Planning Commission Staff Report

File # 6Z25-DCA-000552-2025

Public Hearing and Recommendation to the City Council for a Zoning Map Amendment for Approximately 13 Acres of Property at 4271 S., 4225 S., and 4273 S. 2700 W., from Professional Office (PO) to Site-Specific Development Residential (SSD-R).

Public Hearing and Recommendation to the City Council for a Zoning Text Amendment to Taylorsville Municipal Code, Adopting Chapter 13.45, Standards for the SSD-R Motion Zoning District.

Public Right-of-way
Driveway one side | Rear-loaded Unit other side

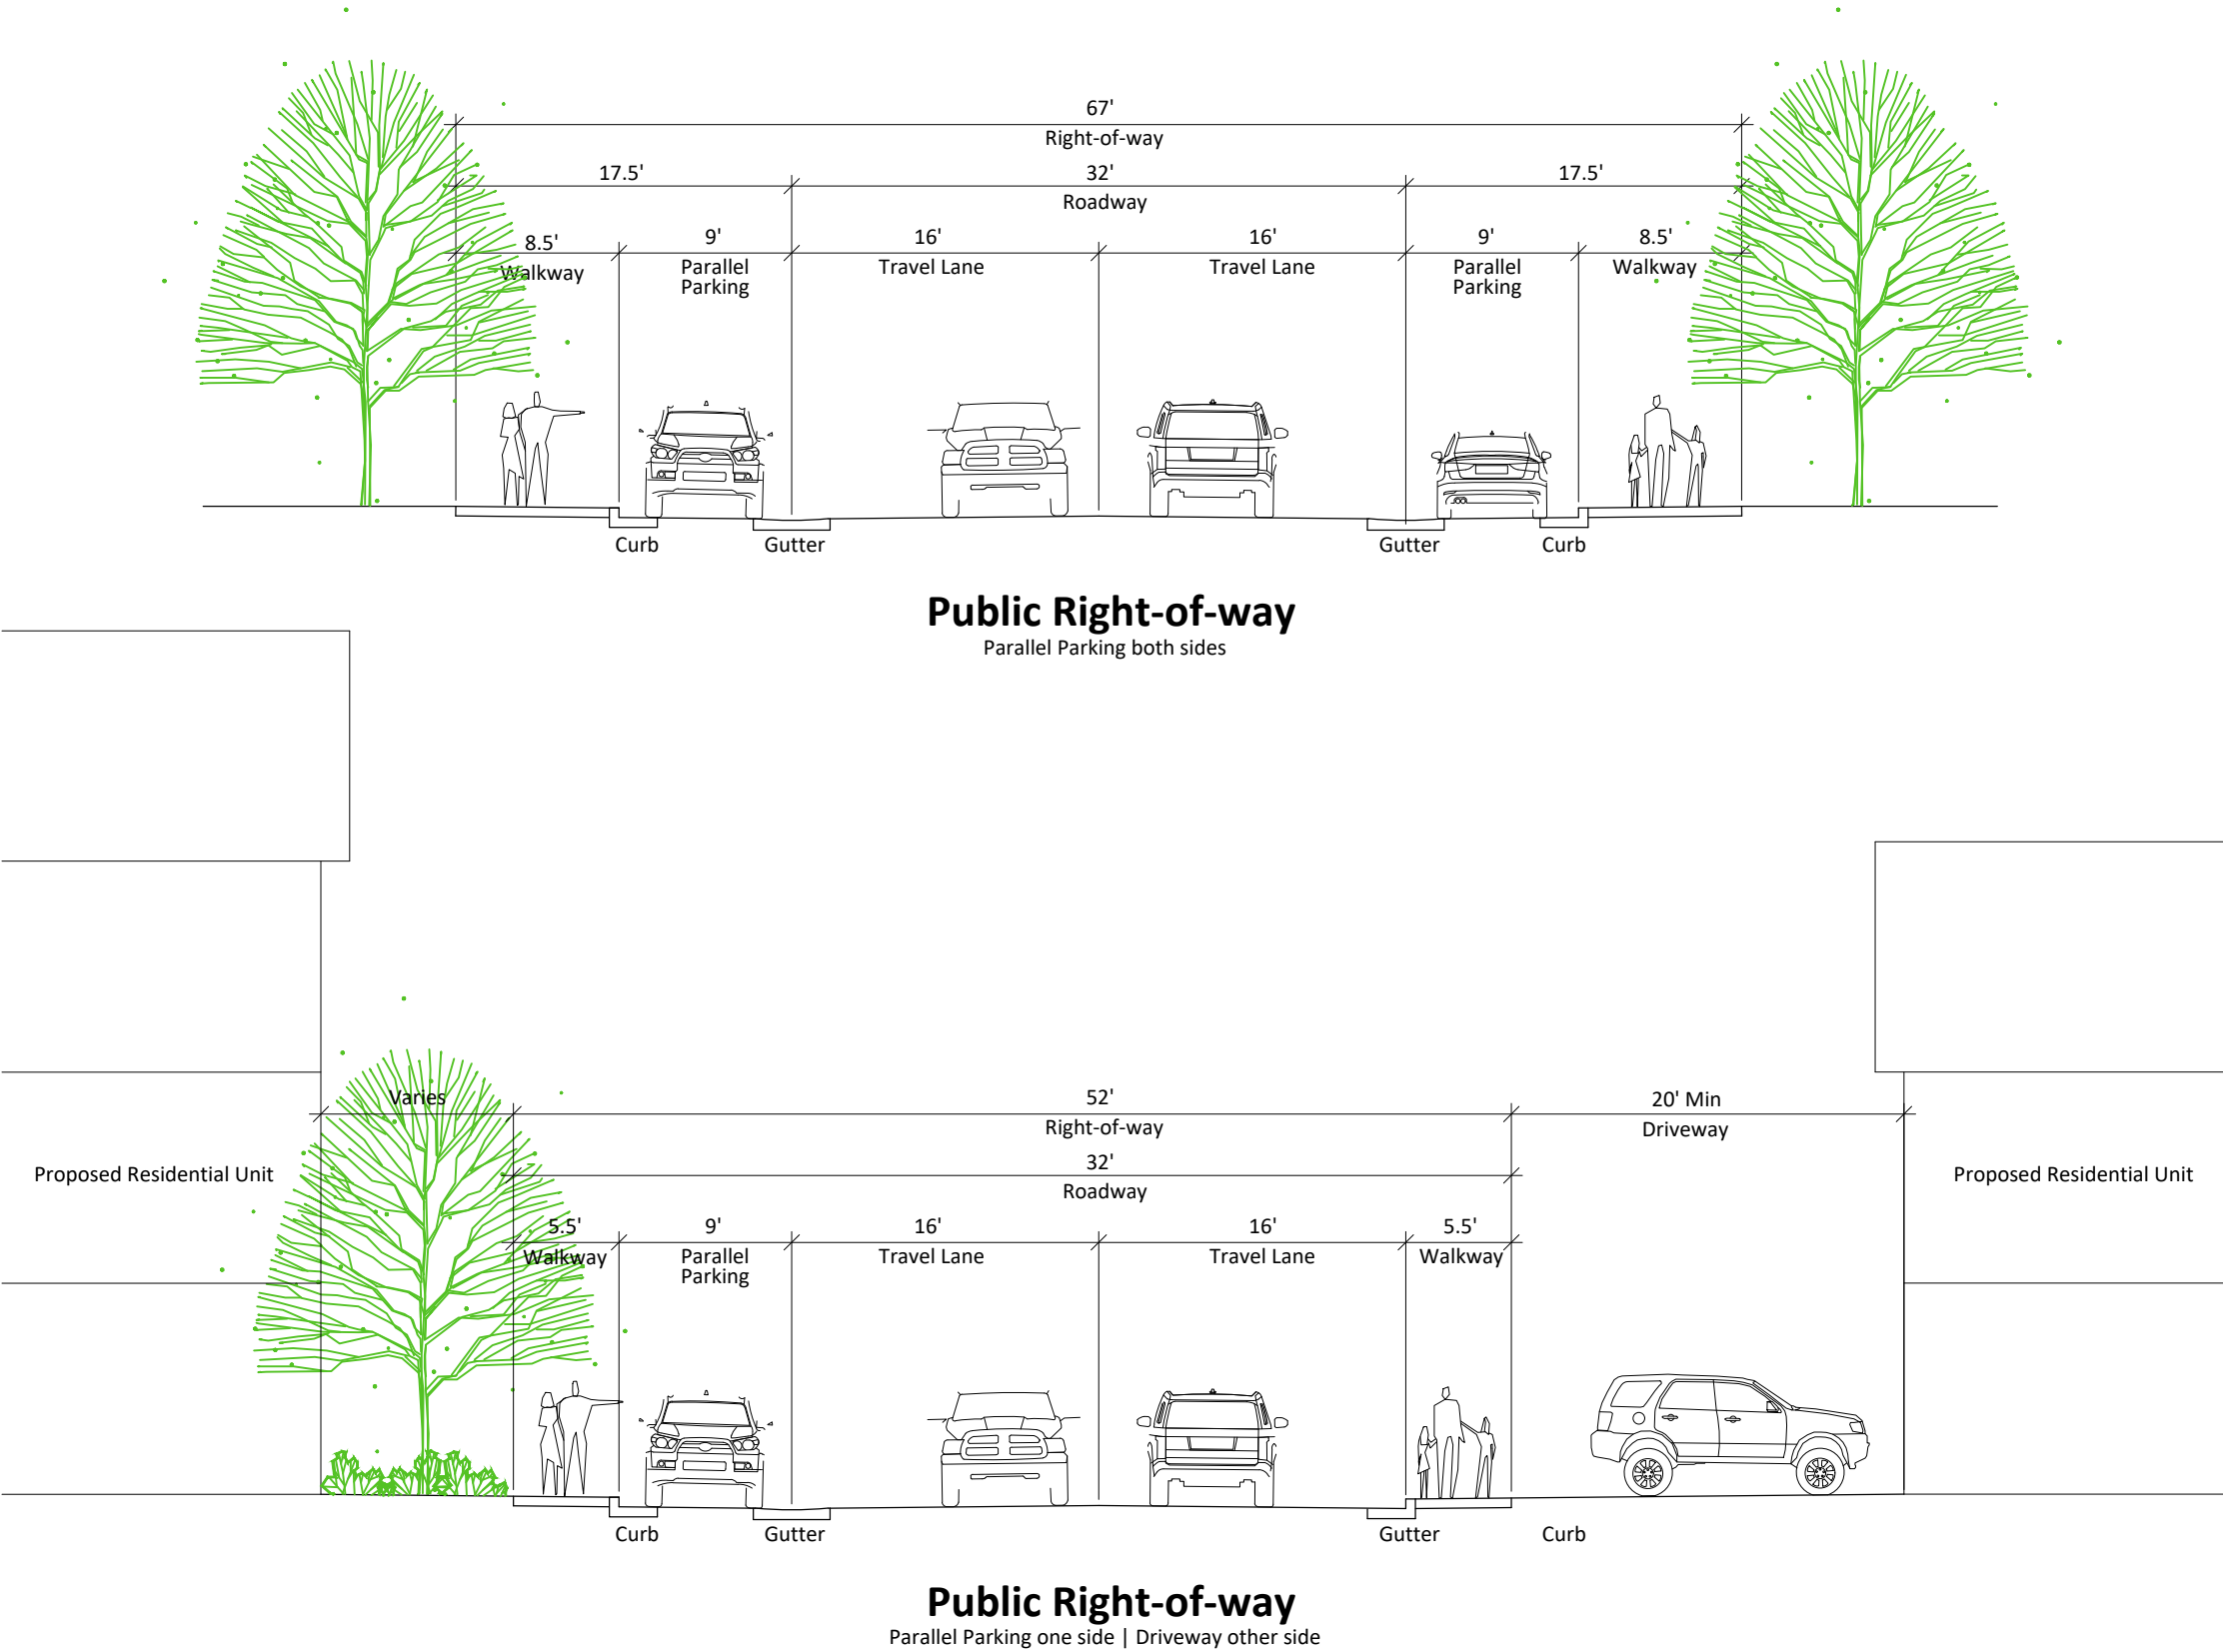
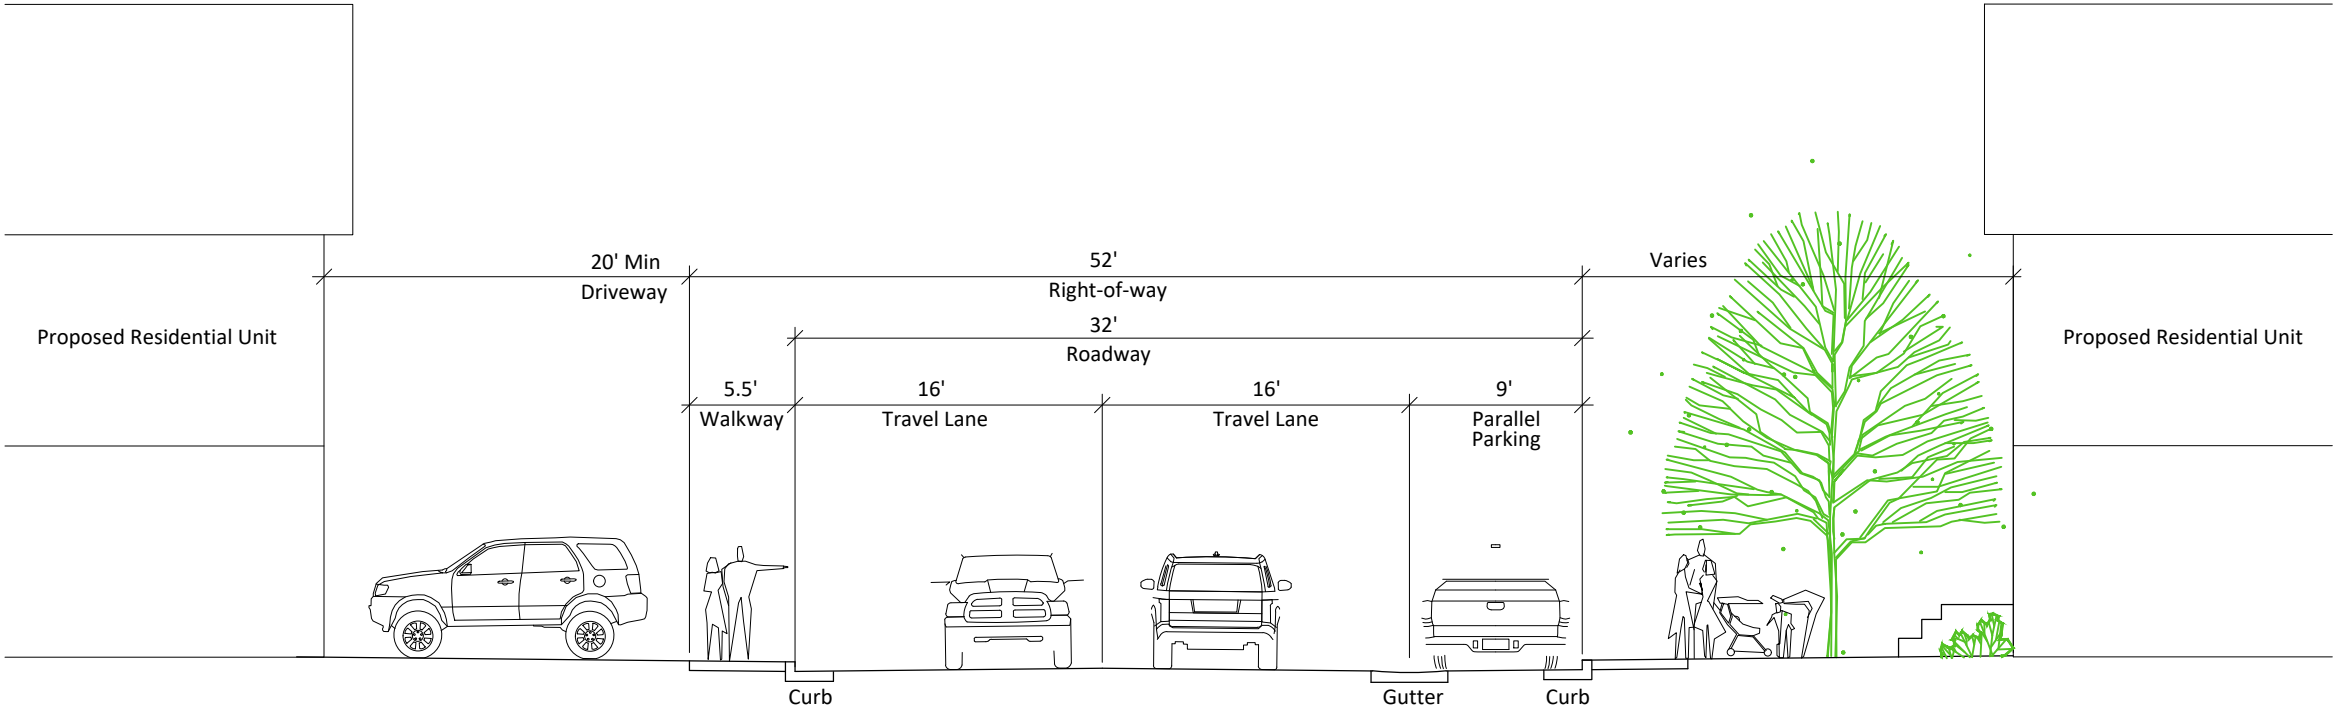
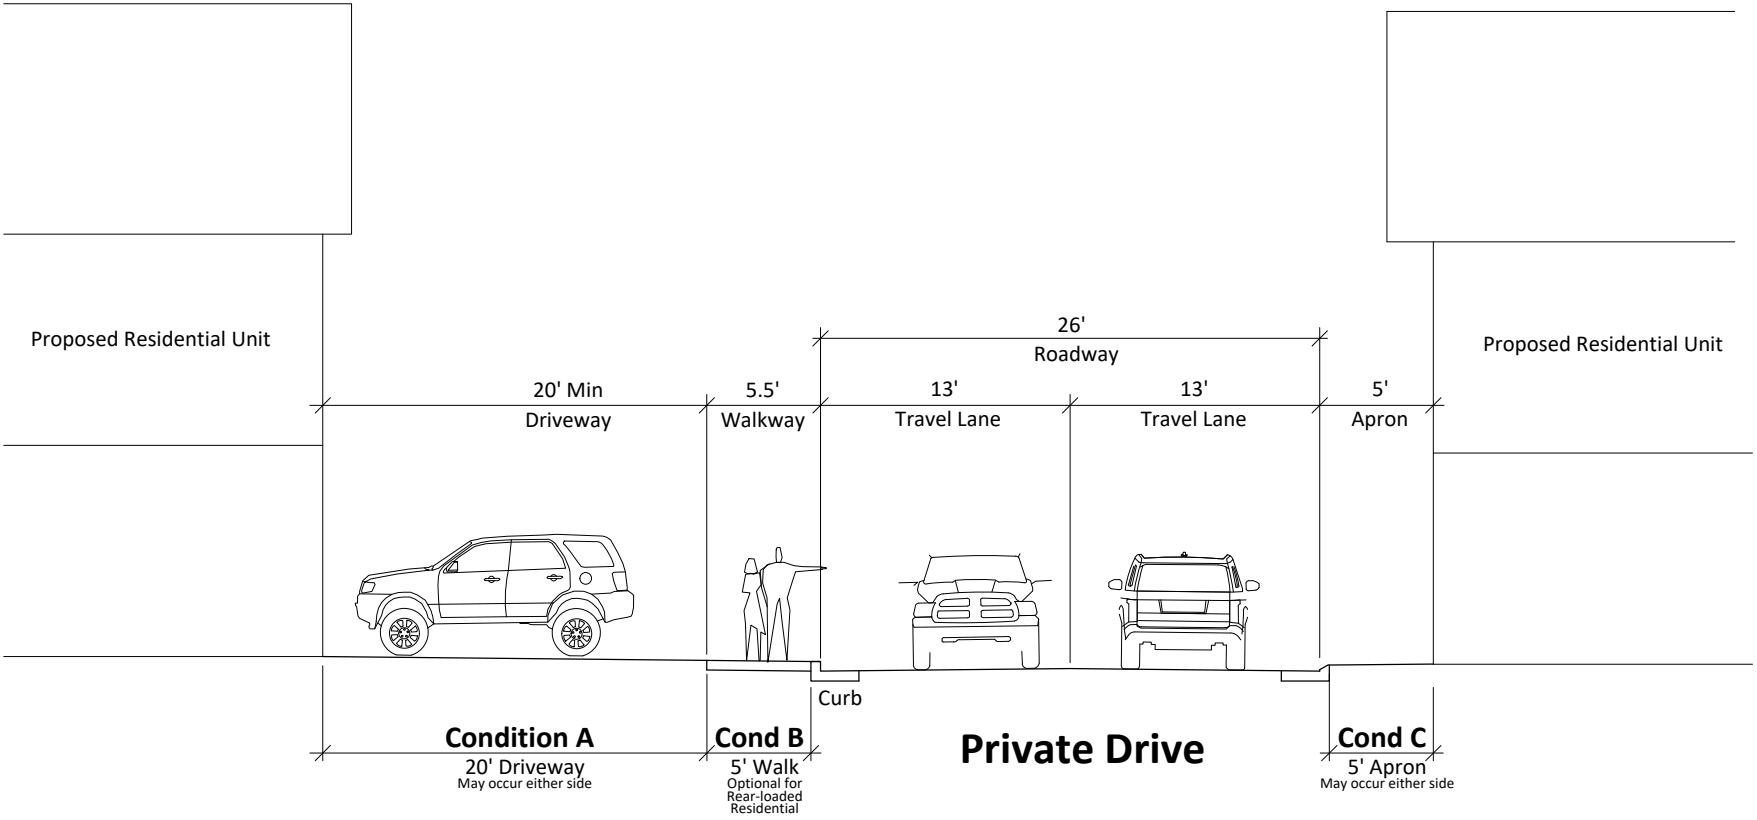
Access to the project from 2700 West will be accomplished by improving the existing drive aisle from 2700 West eastward and connecting to 2440 West, an existing stub street within the adjacent Village II development. The new road will be dedicated as a public right-of-way. The width varies at different segments, but provides no less than 50 feet of right-of-way for the length of the public street, as identified in [§14.12.100](#). The right-of-way narrows in areas to accommodate driveways and housing units, but drive aisle maintains 28' width with increases in areas to allow parallel parking. Sidewalks are maintained on both sides of the E/W public road. Exhibit F includes staff notes to illustrate the widths and location of road types.

As the road turns north to connect with the existing stub street, sidewalks are not shown on the concept. The connection will provide the necessary ingress/egress for resident safety and emergency vehicle access for both the proposed development and existing neighborhood, which currently has only one access to 2700 West. The extension of the public road is required in [§13.21.100](#) street standards of the subdivision design standards of the LDC and supported by several recommendations in the 2025 Taylorsville General Plan to increase connectivity, particularly for neighborhoods in high liquefaction areas with limited ingress/ egress. Exhibit D may serve as the best view of the location of 2440 West and the potential improvement for vehicular circulation. Property owners on either side of the existing stub have structures and/or improvements encroaching within the right-of-way which will need to be resolved prior to the development of the road. A sidewalk and park strip on the west side will be required to connect with the existing public sidewalk system

Wide sidewalks and pedestrian connectivity to and within are emphasized in the submitted concept plan. Cross sections illustrate the proposed public right-of-way connecting to 2700 West to be developed with 8-foot-wide sidewalks on either side (Ex H), which will create a comfortable pedestrian experience. The existing landscaping area around the drive aisle is retained with this concept and will border the wide sidewalks and function as useable open space. The 8-foot-wide sidewalks extend approximately 400 feet into the development and taper down to 5 feet throughout the rest of the proposed project. The enhanced pedestrian experiences connecting to 2700 West support efficient pedestrian access for future residents on either side of the public road to access the new Midvalley Express BRT line bus stop. Staff is also recommending to further General Plan pedestrian connectivity strategies with this project by connecting new sidewalks with at least one of the existing sidewalks within the neighborhood to the north.
